Service Bulletin

Reference #051

**Bender Conveyor Helical Worm Gearbox, Glasstech part numbers listed below
(Manufactured by Nord) installed from December 2003 until November 2006,
Oil Replacement**

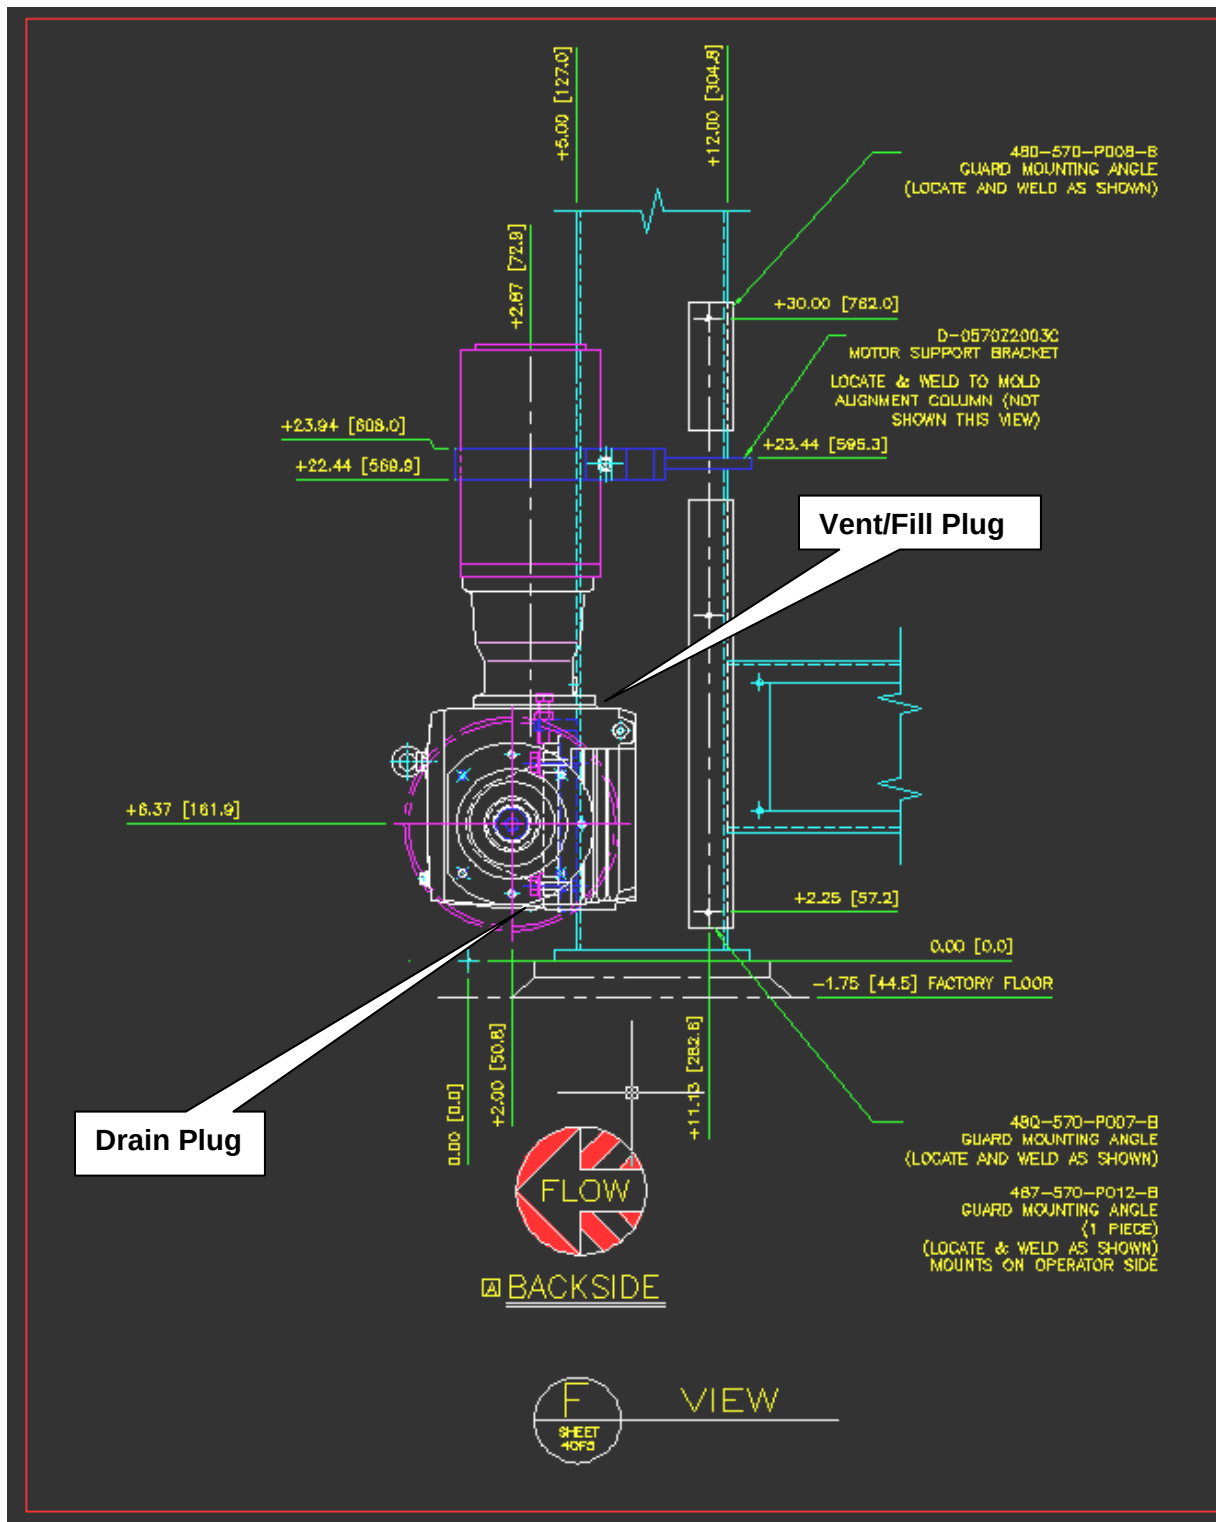
Glasstech recommends that the bender conveyor gearbox oil be drained and replaced with synthetic oil. In a limited number of applications, it is possible that a very low level electrical charge may flow through the gearbox. This low level charge will allow dissimilar metals in the gearbox to erode over time. The dielectric properties of the synthetic oil will greatly reduce the opportunity of an electrochemical reaction occurring. Glasstech, Inc. and Nord recommend the following procedure be used to exchange the oil:

“Nord recommends SHC (Synthetic hydrocarbon) 636 Mobile oil for helical worm gearboxes that are susceptible to low levels of electrical current.”

Procedure for flushing & refilling helical worm gearboxes is as follows:

1. Warm-up gearbox and drain the existing oil (Polyglycol) from Gearbox.
 - To warm-up gearbox run conveyor for approximately 10 minutes or more.
2. Refill the gearbox with 200 viscosity oil and run for approximately 5 minutes.
 - Recommended Flushing Oil: **Keystone Lubricants Nevastane SL460** (Available through Glasstech)
3. Drain the “Flushing” oil and refill with the SHC oil. (The approximate 5% remaining Polyglycol oil in the gearbox is acceptable).
 - Recommended Oil: **Mobile SHC 636** (Available through Glasstech)
 - Gearbox oil capacity: **3 liters**
